RE: 118 Olive Street

I reviewed the drawings and evaluated the site context. My comments and recommendations are as follows:

Proposed Front Elevation

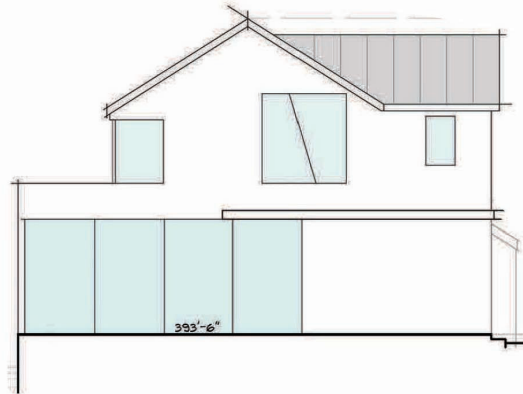
1. The use of stone on the front elevation, while not carrying it around consistently on the other three facades would not be consistent with Residential Design Guideline 3.2.2.

- Carry wall materials, window types and architectural details around all sides of the house. Avoid side and rear elevations that are markedly different from the front elevation.
2. The column detail shown at the entry is not well detailed, and does not look like it is an integral part of the facade,
 3. The existing house is simple in its forms, and the addition should relate to that. However, the garage form and the popout form on the right side elevation at the Family Room/Kitchen are quite foreign to main forms of the house and to each other.
 3. There appears to be no trim at the window, and windows do not appear to be substantially recessed from the face of the wall which would not be consistent with Residential Design Guideline 3.7.4.

- Most architectural styles - except Mission, Spanish Eclectic or Modern - should have wood trim around the windows. The trim width should be matched to the style, but in general, should not be less than 3 1/2 inches wide. Head trim depth should be equal to or wider than the jamb casing, but not less than one-sixth of the opening width.
 - Projecting window sills and heads are strongly encouraged unless the architectural style would not normally have those features.
 - Wood trim is also encouraged on stucco houses unless the window frames are recessed at least 6 inches from the outside face of the wall. The use of stucco covered foam trim is strongly discouraged.
4. Gable roof slopes do not match which would not be consistent with Residential Design Guideline 3.5.1.

1. Use similar flat roof forms on both the garage and Family room/Kitchen popout. Optional usable roof deck over garage for Bedroom 2 and/or Master Bedroom.
2. Integrate the entry column into the garage wall, and add a canopy over the entry and the garage.

3. Recess the garage door - similar to new home nearby to the right (photo below).
4. Match the gable roof slopes.
5. Add trim to all windows consistent with Residential Design Guideline 3.7.4 and recess large windows- similar to new home nearby to the right (photo above).
6. Eliminate the stone on the front facade.
